SIB 52 09 23

RECALL 23V-253: 2nd ROW HEAD RESTRAINTS

This Service Information Bulletin (Revision 2) replaces SI B52 08 23 **dated April 2023**.

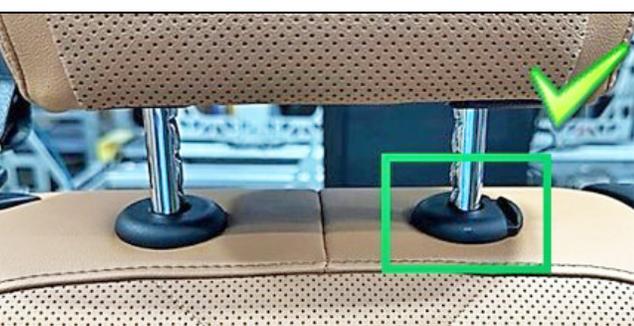
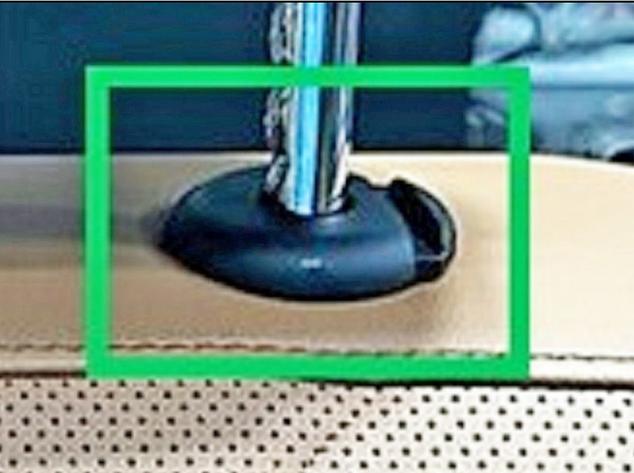
The second-row seats have head restraints from the seat supplier that may not meet specifications. The head restraint guides may not have a locking tab. In certain crashes, if the head restraint were to move downward, this could increase the risk of injury.

The second-row seats have head restraints from the seat supplier that may not meet specifications. The head restraint guides may not have a locking tab.

<p>Headrest guide sleeve not OK (without lock).</p>
	<p>Headrest guide sleeve OK (with lock seen on the right side of the right post).</p>
	<p>Close up view, headrest guide sleeve OK (with lock).</p>
	<p>If either head restraint is missing the locking type sleeve, then the head restraint must be removed for the lock to be installed.</p> <p>Remove the headrest guide cap, press up with your finger to release the cap (both sides of the affected head restraint).</p>
	<p>Press button A on both headrest guides in the direction shown and move the headrest upwards out of the lock position.</p> <p>Then replace the sleeve in accordance with repair instructions 52 26 394 (rear headrest guide...; Attachment).</p>

Check the outer rear seat guide sleeves (left and right) of the head restraints on the second-row seats and replace if necessary.

Check the outer headrest guide sleeves on both second-row seats' head restraints.
